Application Serial No. 10/623,983

REMARKS

FIG. 1

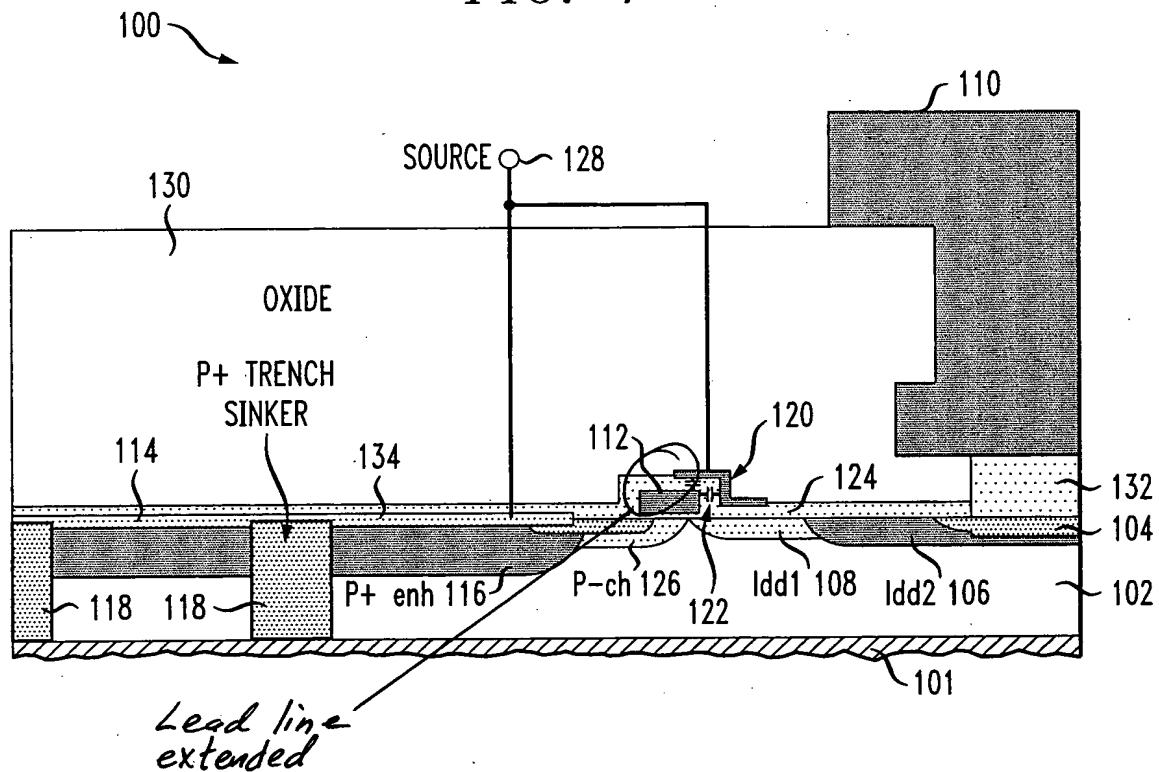
In this response, FIG. 1 has been amended in order to correct an error of a typographical nature, as suggested by the Examiner. A replacement Sheet 1, which includes FIGS. 1 and 2, is attached herewith. Applicants traverse the objection of the drawings with regard to FIG. 2. Applicants traverse the §112, §102 and §103 rejections of the claims for at least the reasons set forth below. Applicants respectfully request reconsideration of the present application in view of the above amendments and the following remarks.
